# TECHNICAL MEMO

**To** Linda Riley**From** Biljana Rajlic**Date** July 11, 2012**Project #** 285380**Reference** Tunnel watertightness**Page** 1 of 16**CC**

## PART 2 – RESPONSE TO HMQ COMMENTS

Figure 7: Ground Improvements Sections I, T10B

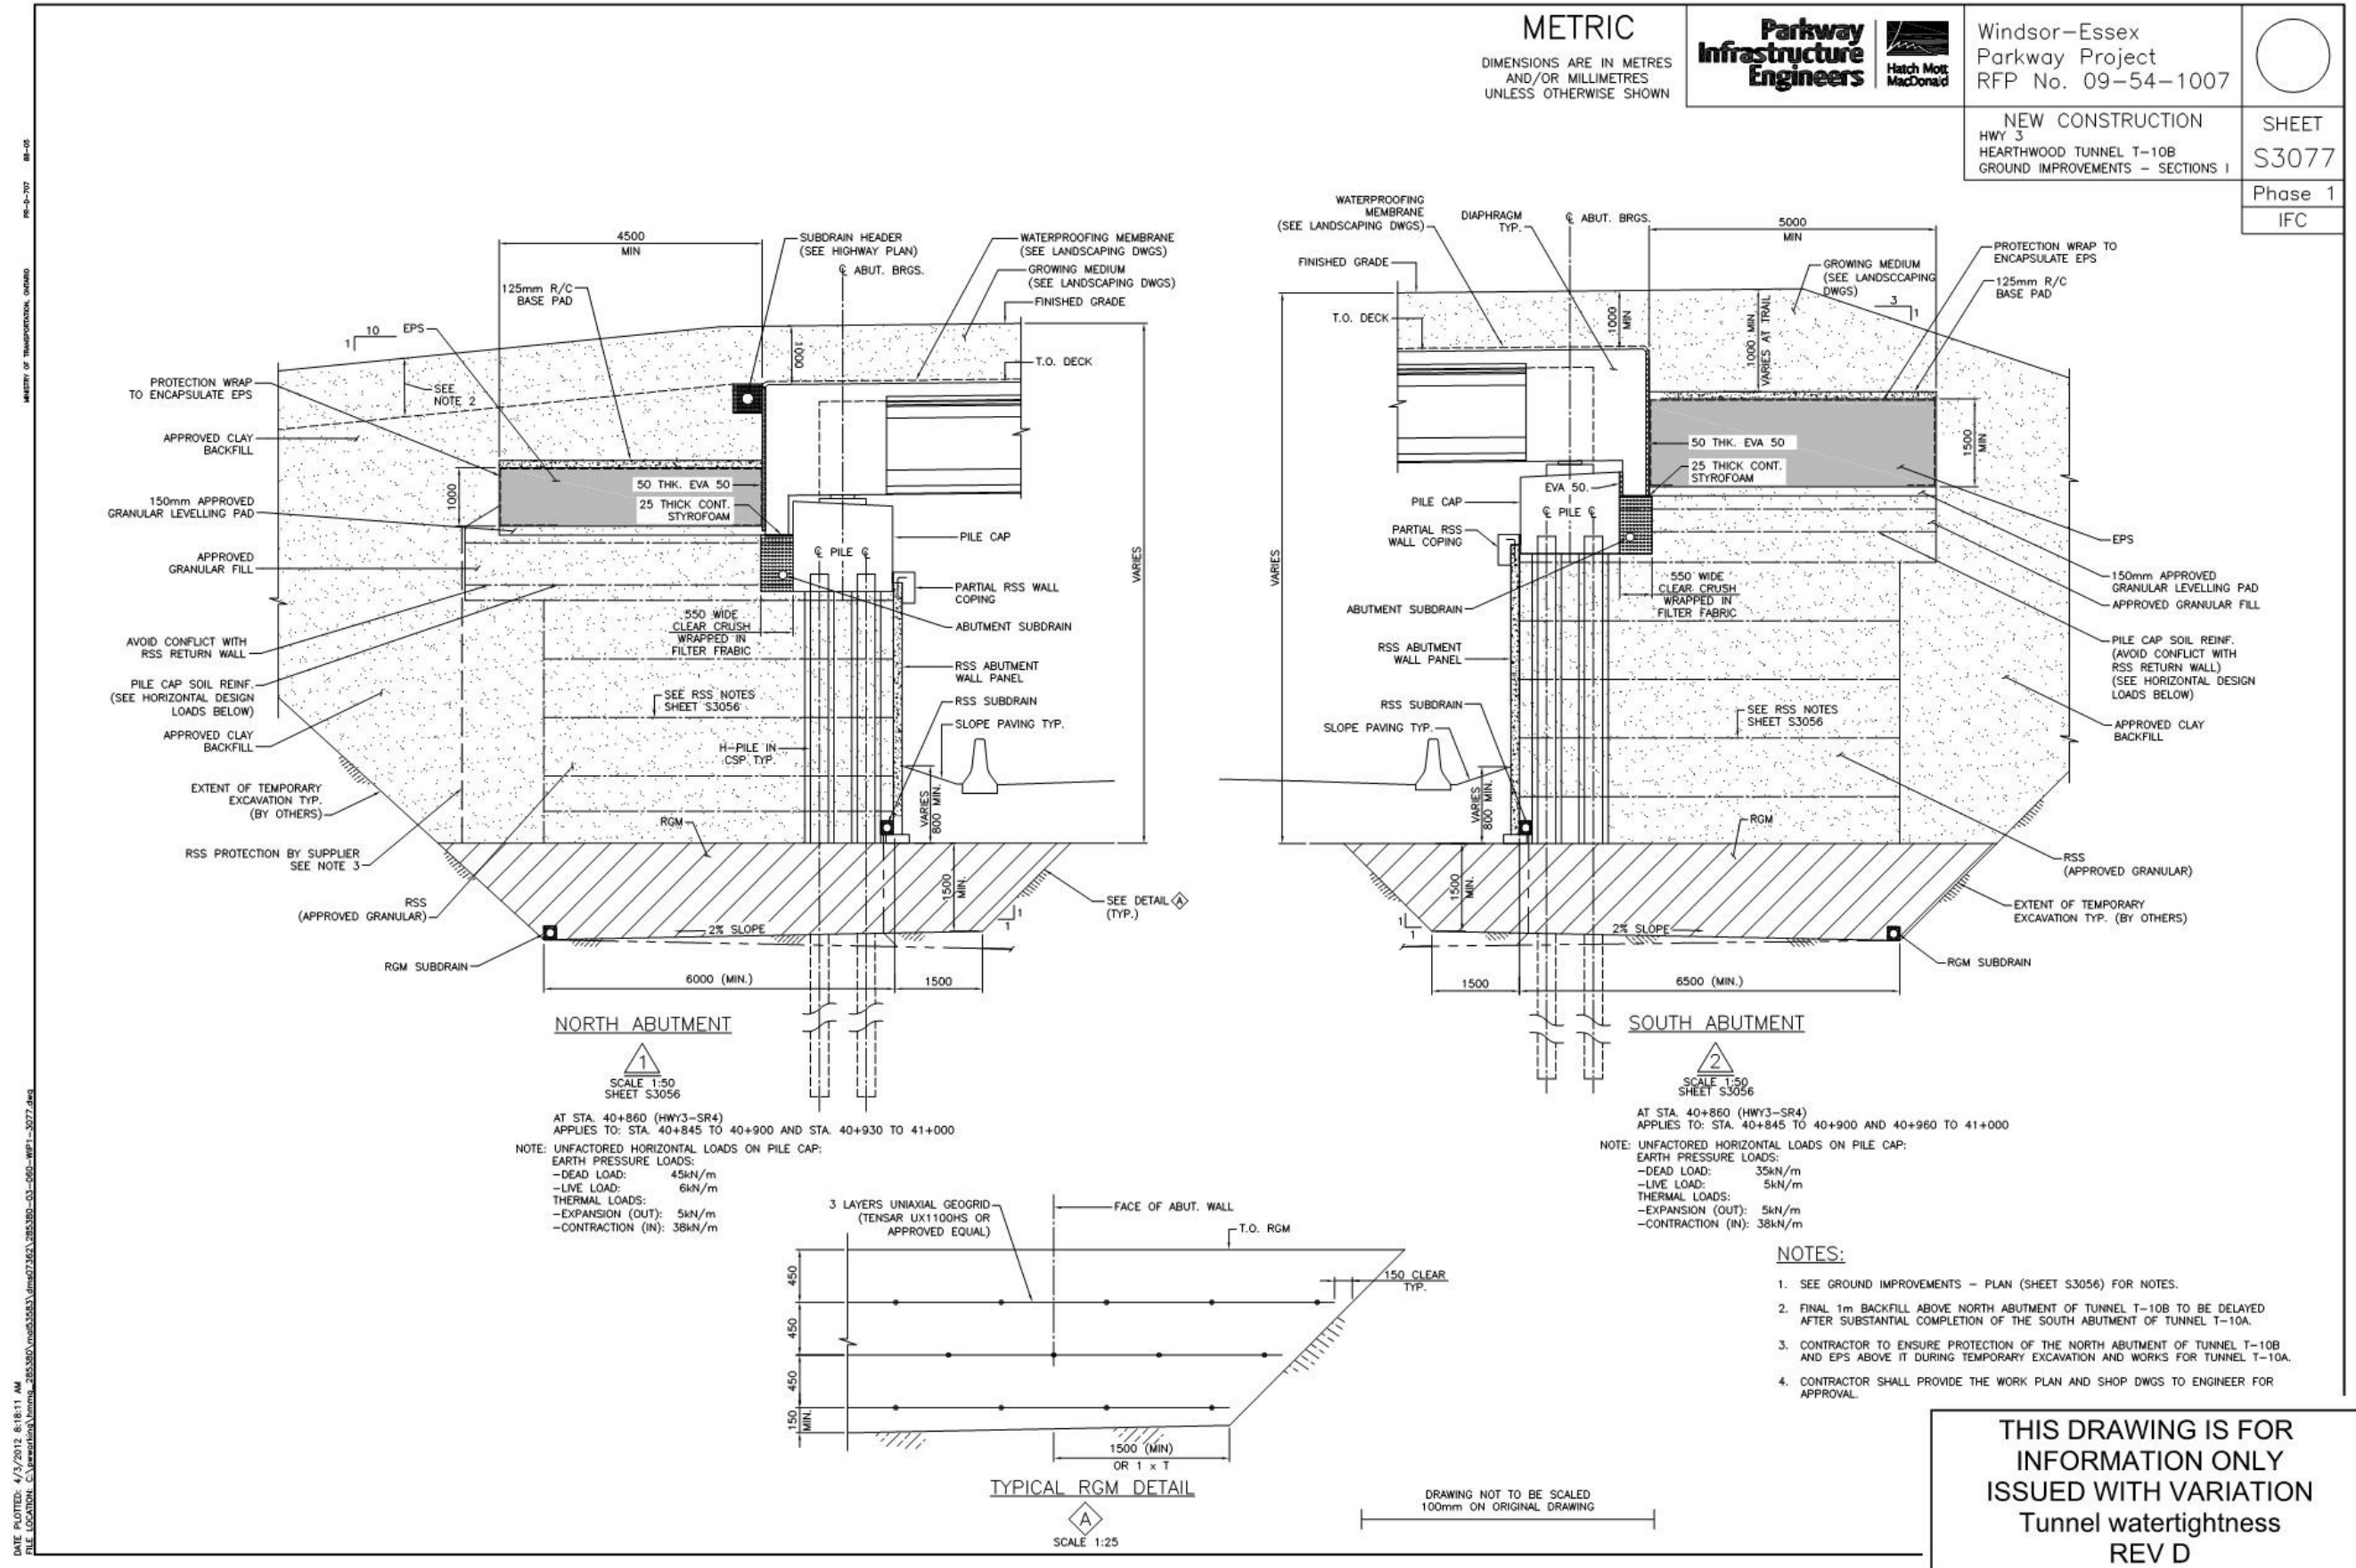
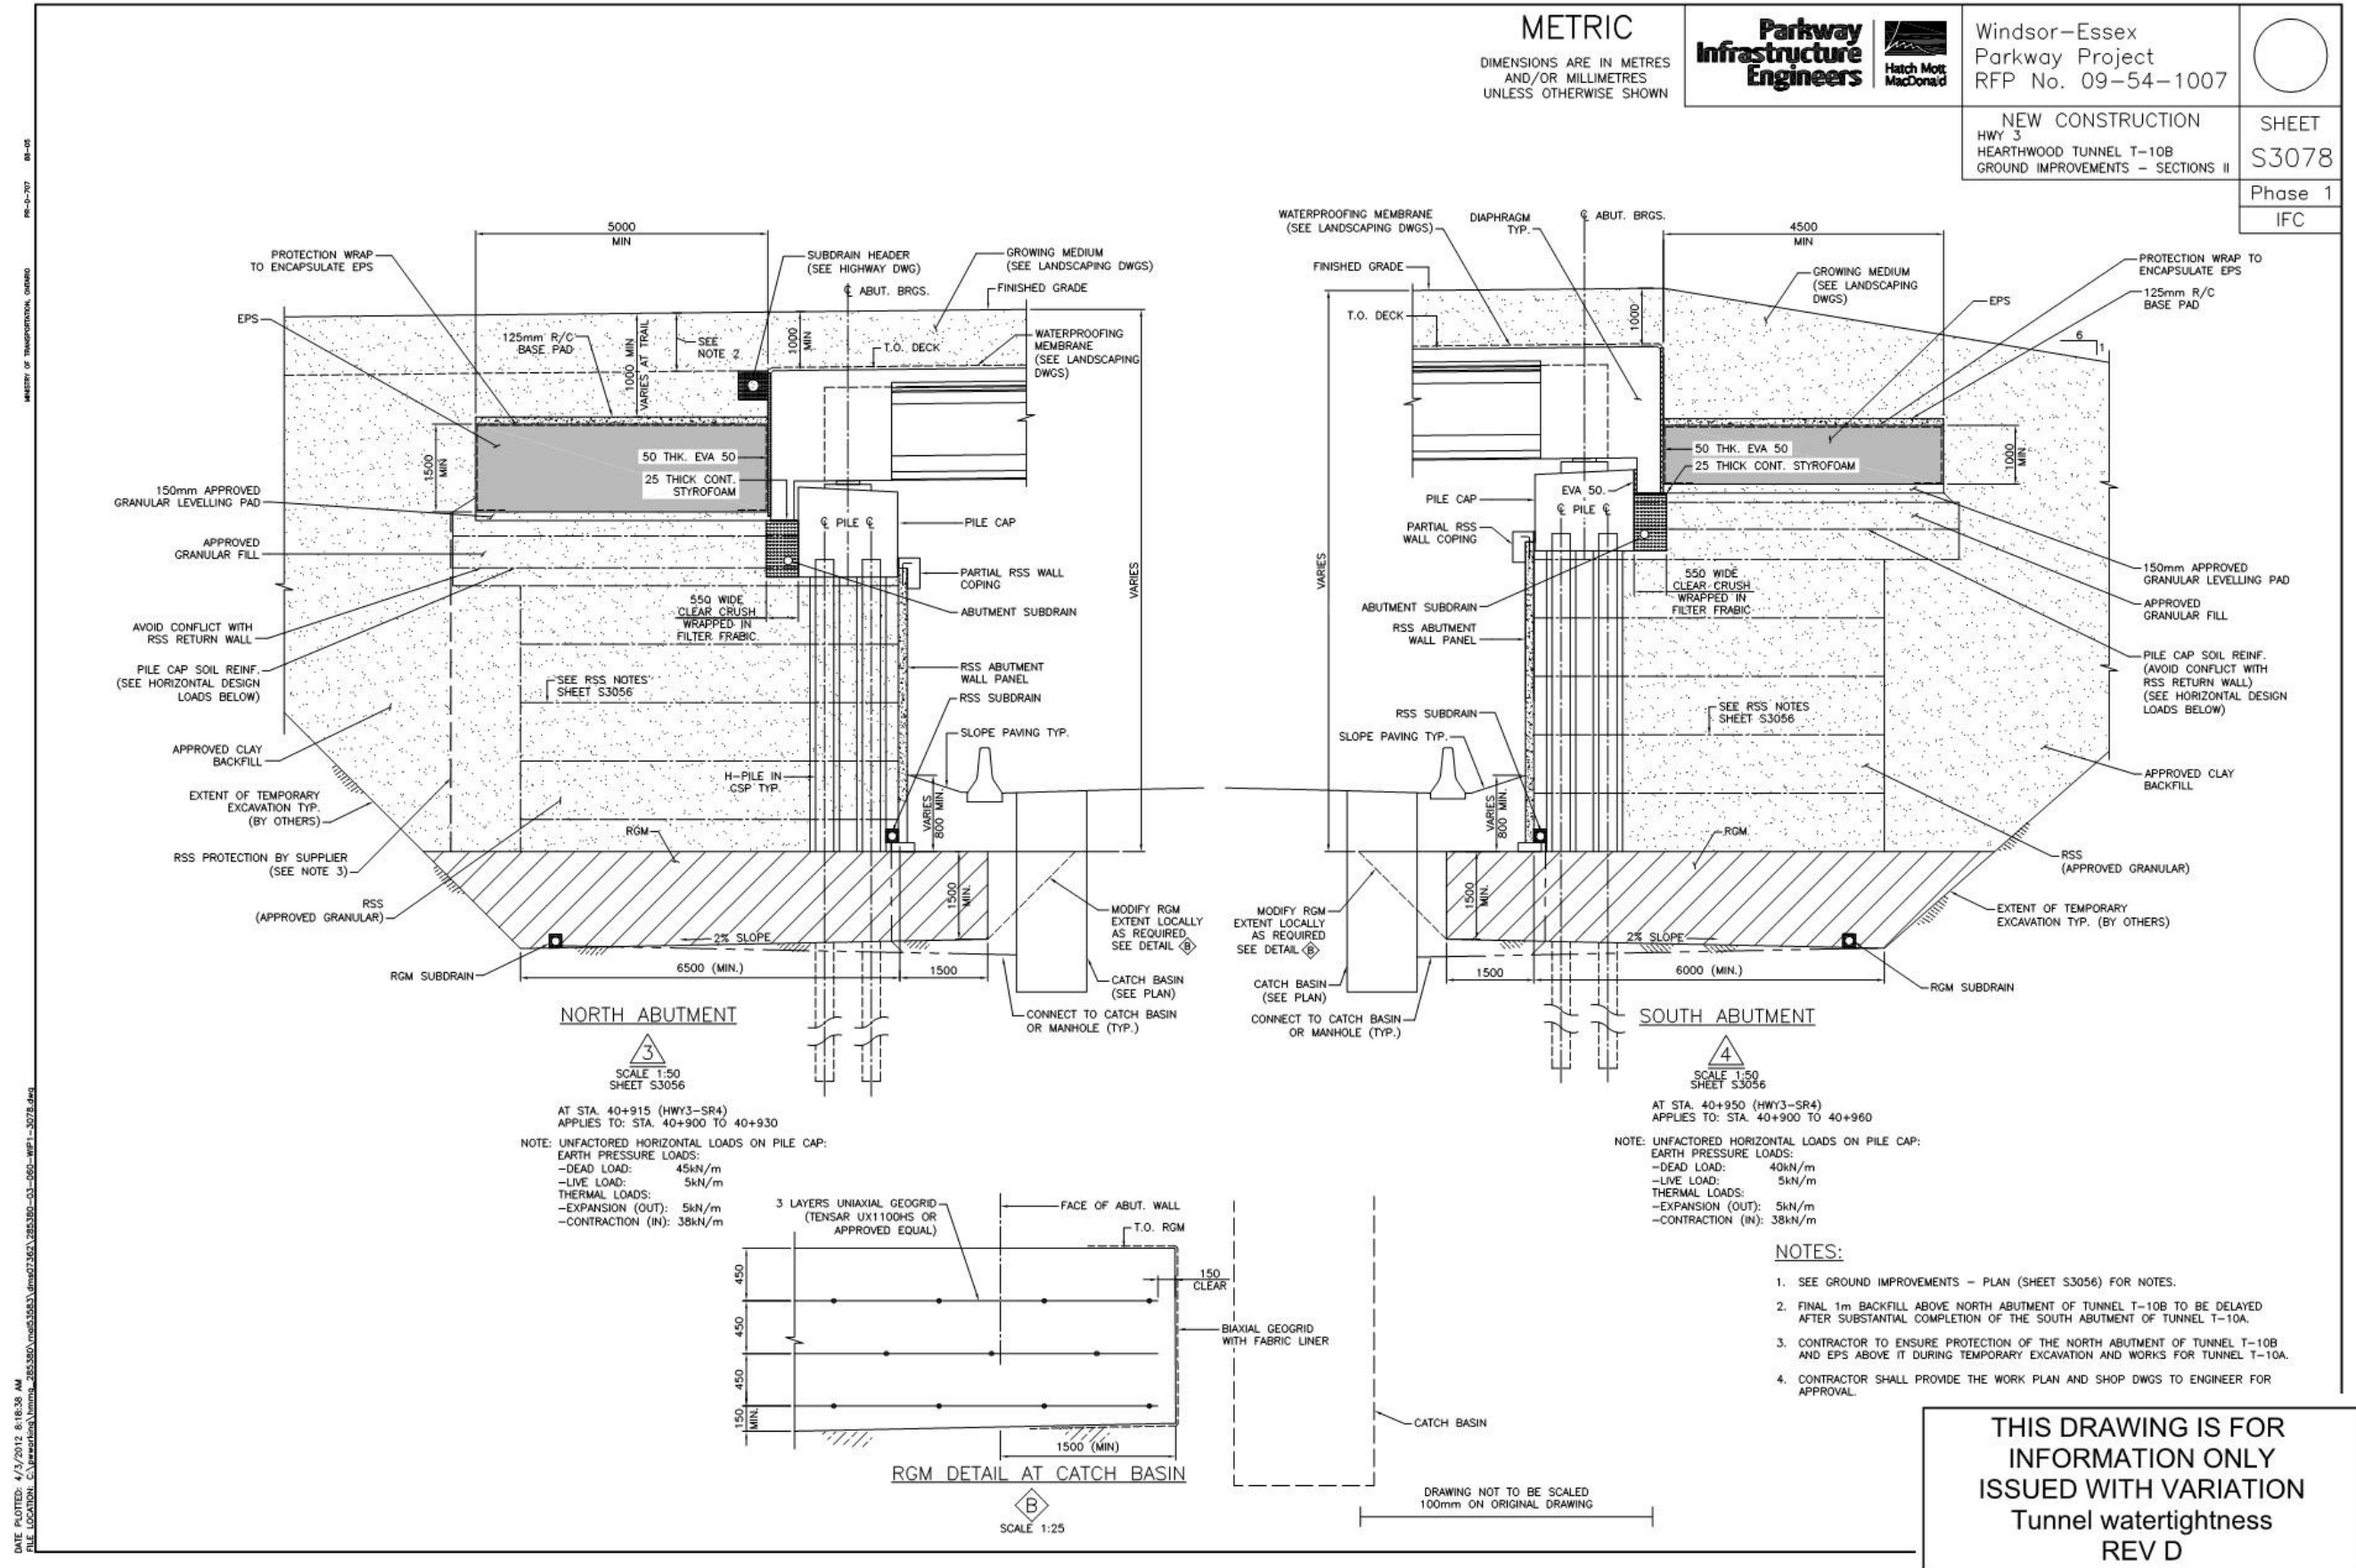
HMQ comment: "HMQ would consider the four (4) lines of subdrains identified in Section 4 of PIE's memo (enclosed with PIC's letter) on their own to be non-compliant as the EPS could act as an impervious layer thus causing water to build up behind the abutment."

- 1) HMQ does not agree that the water settled above the flat EPS will simply drain around the EPS. This would require some sort of hydraulic pressure or gradient to push it away. How does PIC intend to achieve this?

Ground Improvement drawings showing subdrain locations for T10B are provided in Figures 6, 7, and 8. This subdrain arrangement is typical for all WEP tunnels. At T10B the deck drains towards the north abutment. Water draining off of the back edge of the north abutment diaphragm is captured in the trench formed by an impermeable membrane attached to the waterproofing and protection board, and drains into a 200mm diameter subdrain header pipe. The details of this header pipe are shown in the Highway New Construction Drawings and are provided again in Figure 5. Water collected by the header pipe is drained to the Highway 401 storm sewer network.

The quantity of water above the EPS at the higher side of the deck (for T10B, the south side) will be much smaller than at the lower side, and, in terms of drainage design, subdrains are not necessary above the EPS at the higher side. If any water is trapped on top of the reinforced concrete slab above the EPS, it will simply drain around the EPS block to the 3 available subdrains below. The top of the concrete slab will be graded at a minimum of 0.35% away from the abutment to facilitate the drainage of water to the subdrains.

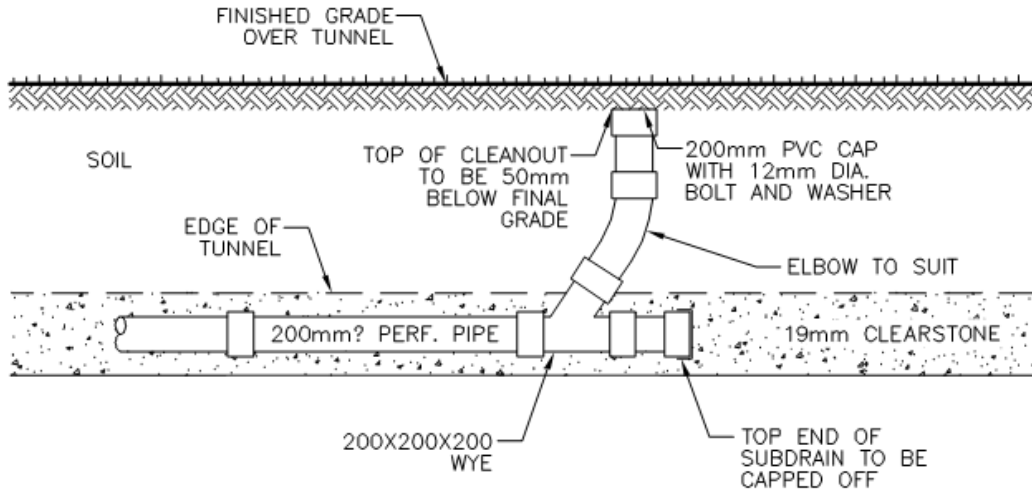
- 6) In Figure 5 there is a lack of detail to address the prevention of water from getting beneath

the membrane and avoiding the sub drain altogether. Detail needs to be provided for the planon (dimpled drainage board).

**Figure 9: Typical cleanout details** (extract from Highways design submission)

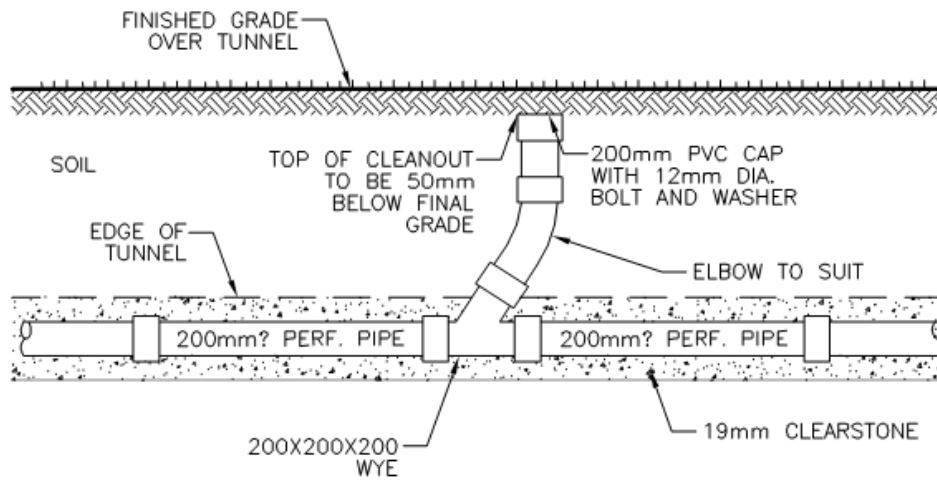
HMQ comment: "...As each of the 5 lines of subdrains has a specific purpose for the drainage of a specific area of the structure, the subdrain system may not provide sufficient redundancy in the event that one or more pipes become blocked. WEMG should propose a means of monitoring the performance of the subdrain system and removing any plugs. Further detail should also be provided for the "Cleanouts" shown in Figure 3."

- 4) Maintenance procedures regarding the cleanouts is vague and needs to be documented and detailed. We understand cleanouts will be present but how will WEMG determine that the subdrains are clogged? When will inspections happen and what will determine that flushing will be needed? This is critical to ensure the subdrains will operate continuously.

Further detail for the "Cleanouts" has now been provided in the Highways design submissions. Typical details are shown in Figure 9.
